PRODUCT / PROCESS CHANGE NOTIFICATION

1.1 Company		STMicroelectronics International N.V
1.2 PCN No.		MDG/22/13483
1.3 Title of PCN		STM32G050x, STM32G051x and STM32G061x 64K - product enhancement
1.4 Product Category		STM32G050x, STM32G051x, STM32G061x
1.5 Issue date		2022-06-28

**STM32G050x, STM32G051x
and STM32G061x 64K - product enhancement**

Example: Marking on package UFQFPN 7X7X0.55 48L

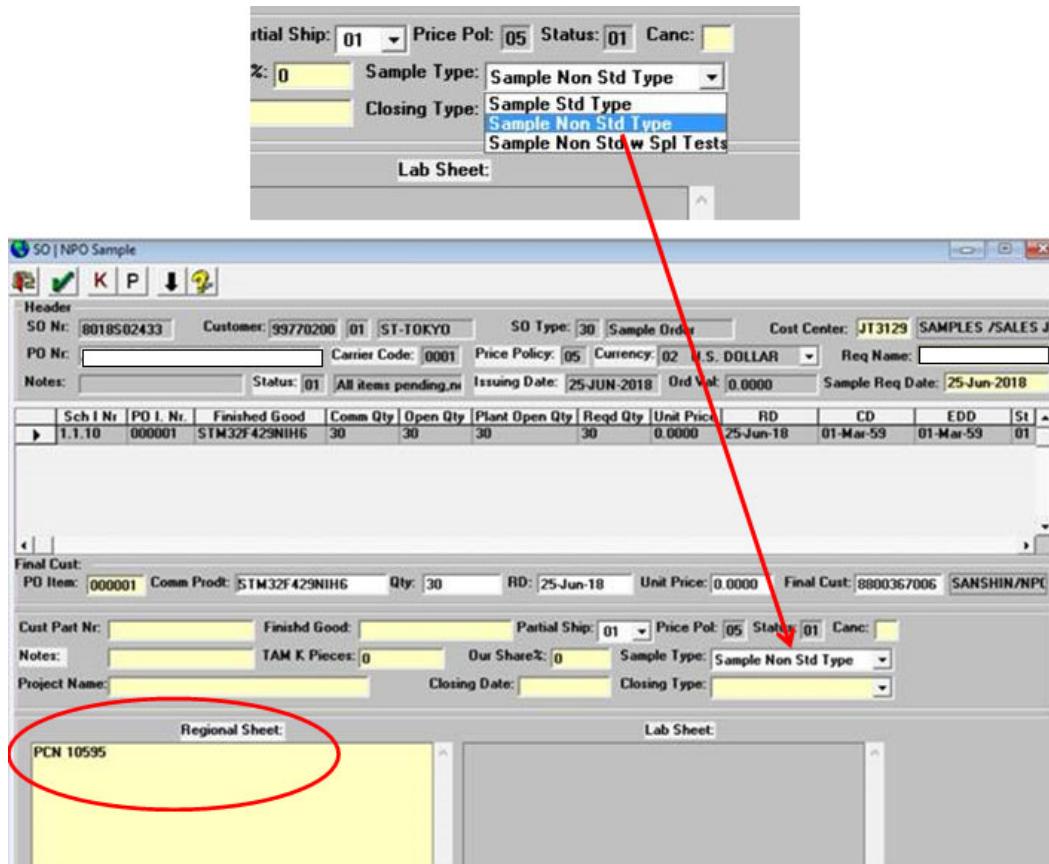
STM32G050x, STM32G051x, STM32G061x	Current Cut1.0	New Cut1.1
Die revision Marking R	“A”	“Z”
